**UNITED NUCLEAR
CORPORATION**

DOCKET NO. 70-820

SUBJECT: SNM-777 LICENSE FOR FUELS RECOVERY PLANT,
WOOD RIVER JUNCTION, RHODE ISLAND

INSIDE STORAGE FACILITIES
STORAGE SHELVES (REF. PARAGRAPH 504.3)

INSIDE STORAGE SHELVES.
REF. PARAGRAPH 504.3

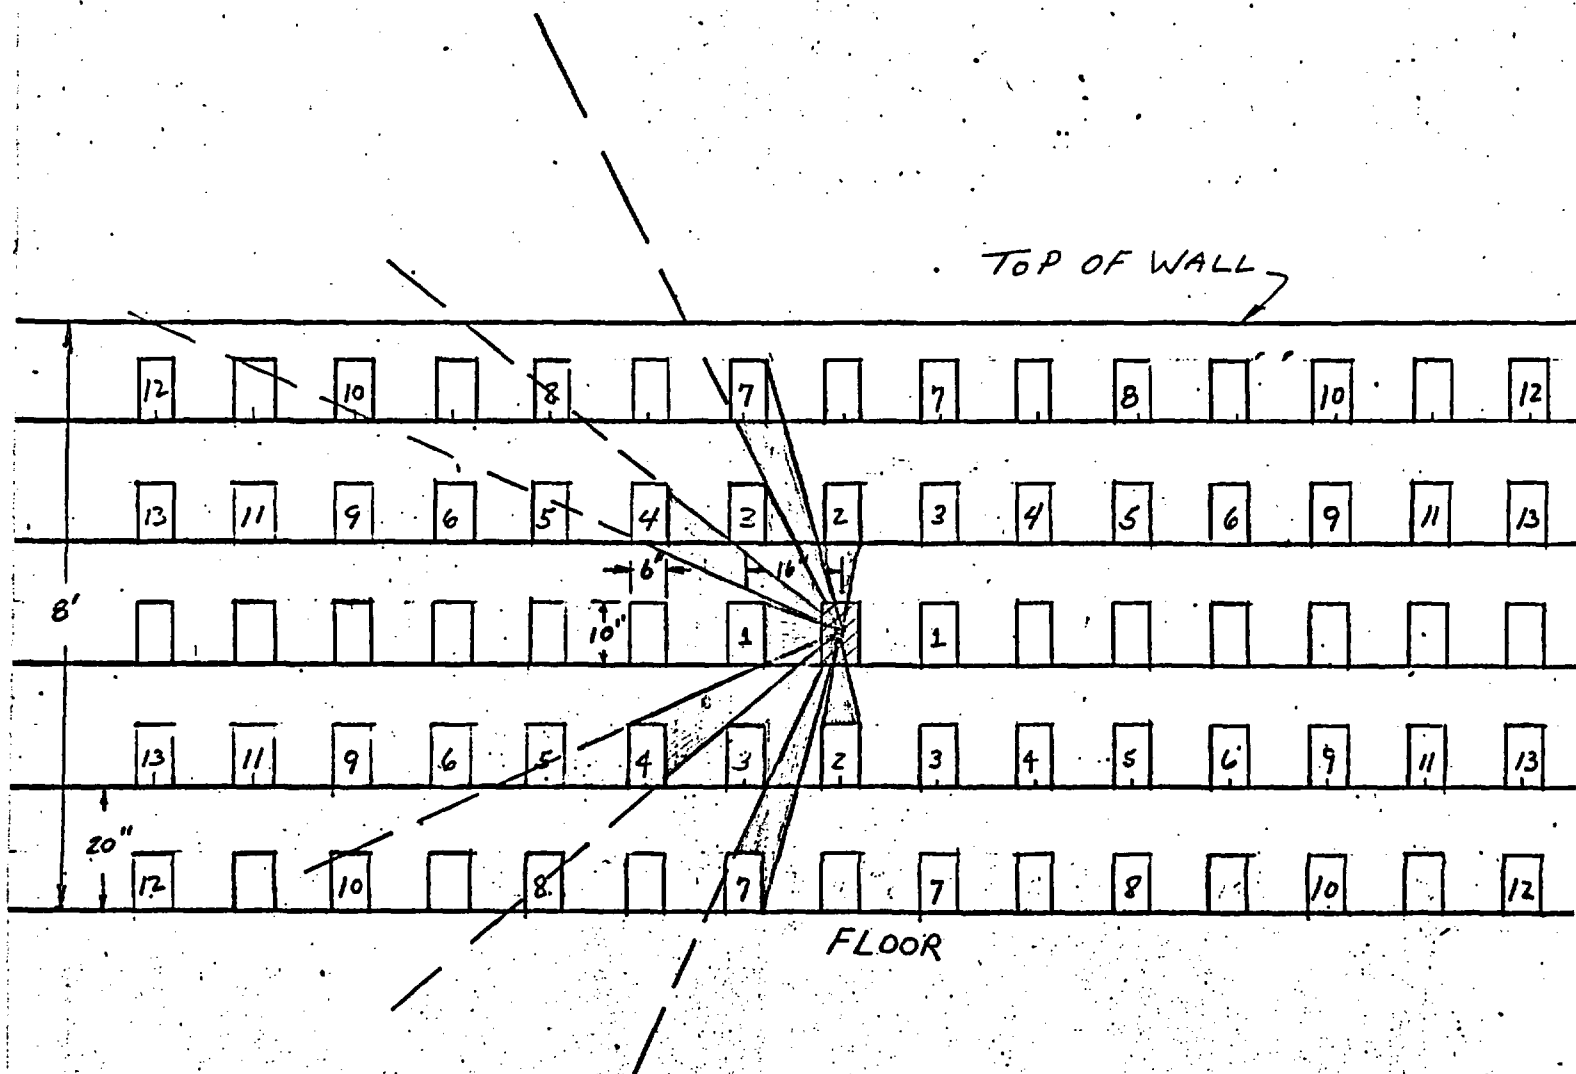
WE ARE RESPECTFULLY REQUESTING AMENDMENT OF SNM-777 TO INCLUDE A REVISION TO THE STORAGE ARRAY DESCRIBED IN PARAGRAPH 504.3 OF "GENERAL INFORMATION AND PROCEDURES APPLICABLE TO THE HANDLING OF SPECIAL NUCLEAR MATERIAL". THE ONLY CHANGE IN THE ARRAY IS THE HORIZONTAL SPACING OF INDIVIDUAL CONTAINERS---THE ORIGINAL SPACING OF 32" CENTER TO CENTER BEING REDUCED TO 16" CENTER TO CENTER.

A REVISED SKETCH OF THE ARRAY AND SOLID ANGLE CALCULATIONS ARE SUBMITTED HERewith FOR YOUR REVIEW AND APPROVAL. YOU WILL NOTE THAT THE SOLID ANGLE CALCULATED FOR THE ENTIRE ARRAY IS 2.56 STERADIANS. THIS INCLUDES THE SOLID ANGLE SUBTENDED AT THE CENTRAL UNIT BY ALL THE NUMBERED UNITS ON THE SKETCH. HOWEVER, ONLY UNITS NUMBERED 1, 2, 3, 4 AND 7 ARE "VISIBLE" TO THE CENTRAL UNIT. THE SOLID ANGLE IN THIS CASE IS ONLY 2.10 STERADIANS. AS DESCRIBED IN PARAGRAPH 504.3, THE SAFE SOLID ANGLE IS 3.0 STERADIANS.

GRAND TOTAL 2.556

TOTAL FOR BOTTLES 1, 2, 3, 4, 7 IS 2.104 STERADIANS.
